11th Avenue MOD Studios

MOD Studios 11th Avenue Mixed-Use Apartments

4510 11th Avenue NE Project # 3019455 Meeting date: 05-23-2016

Design Recommendation # 3019455 Evergreen Lodging, LLC MEETING DATE: 05-23-2016 IOHNSON BRAUND INC.

EDG RESPONSE - MASSING

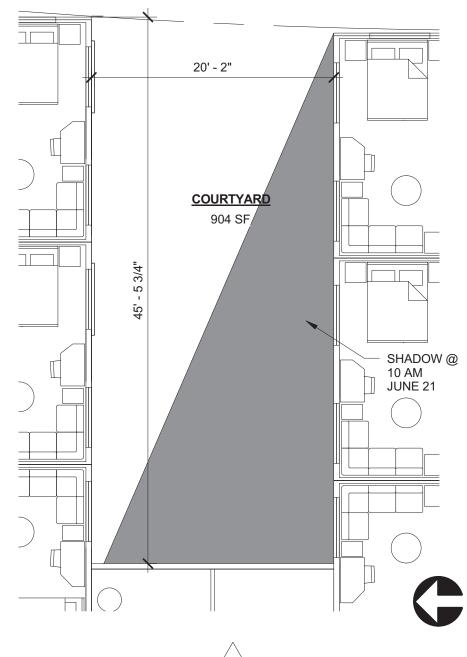
a. In refining either scheme, the Board noted that the proposed courtyards are narrow and recommended looking at the proportions of the courtyard spaces to create access to light and air. (Guideline CS1-B).

The courtyard proportions have been revised to open up more to the alley. Original courtyard dimensions were a constant 20 ft. width. A revised building plan with units stepping back creates an increasing courtyard dimension to approx. 26 ft. at alley. The stepping of the units also allows for corner windows in the units providing more access to daylight. To further increase the access to daylight, light colored finishes, large windows and juliette balconies are utilized in the courtyard exterior elevations. The level two terraces within the courtyards provide private patios and large landscaped areas, including trees and vertical greenscreens that will help to mitigate the tall vertical proportion and provide a buffer/screen between units. The use of courtyards along the alley elevation provide an acoustical buffer from street & alley vehicular noise and visual buffer to windows across alley in adjacent buildings (AVA Apartments & Marriott Residence Inn Hotel).

See sheet 15 for original EDG courtyard plan dimensions & current proposed courtyard dimensions and views.

EDG RESPONSE - COMMERCIAL PEDESTRIAN ARCADE

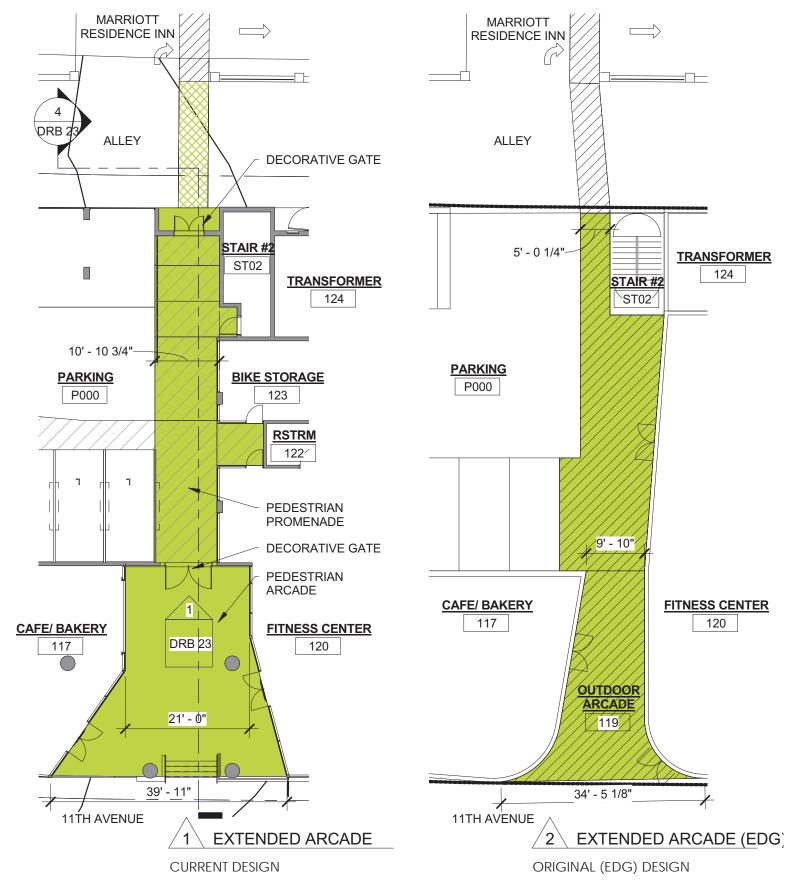
- a. The Board was concerned about the openness and transparency of this space and recommended expanding the height and width. To provide a space that is inviting and visible from both ends, the Board also suggested elements such as wayfinding and compelling lighting be considered. (Guidelines PL1A-2, PL2-D-1, PL3-C-1, PL3-C3, DC4-C-1)

- b. Recognizing the challenge of transitioning this feature from the adjacent parking use, the Board stressed the importance of the design and material treatment of the arcade. A wall separating the pathway and the parking should be considered; such a wall could be translucent or located at an oblique angle to still be perceived as open. To prioritize and convey a sense of the pedestrian connection, the Board suggested exploring pedestrian materials, such as brick pavers, for the garage. (Guidelines PL1-A, PL3-C-1, PL3-C3, DC4-I, DC4-D-2)

- c. The Board also discussed the design and security of the entries for this area and would like to see more detail about access and the consideration of future flexibility, (Guidelines PL2-B, PL3-A-1, PL3-A-4, PL3-C-1, DC3-A-1)

A. The width of the proposed commercial arcade has been increased to allow for ample outdoor seating areas, landscaping and circulation through the space, to the commercial entries and to the garage parking & hotel connection across the alley. The width also corresponds to the exterior elevation unit expression above (3 bays). See exterior elevation.

See sheet 21 for dimensioned arcade plan as shown at EDG meeting and current proposed plan. The arcade is raised above the sidewalk with a central stair flanked by concrete columns and an accessible route as the sidewalk slopes up to the north. Large storefront glazing is provided along both edges with high visibility to the commercial uses: a Bakery to the north and fitness center (resident/commercial) to the south. Operable overhead doors are proposed at the bakery to connect indoor & outdoor seating areas. Bike storage and rental space is visible just beyond the gate.

Wayfinding elements are utilized to emphasize the pedestrian connection through the space. Wood soffiting and linear LED lighting overhead and concrete patterned paving below lead one through the space and beyond connecting through the garage to the alley (and hotel beyond). A decorative and transparent gate provides visibility through the space to connections beyond.
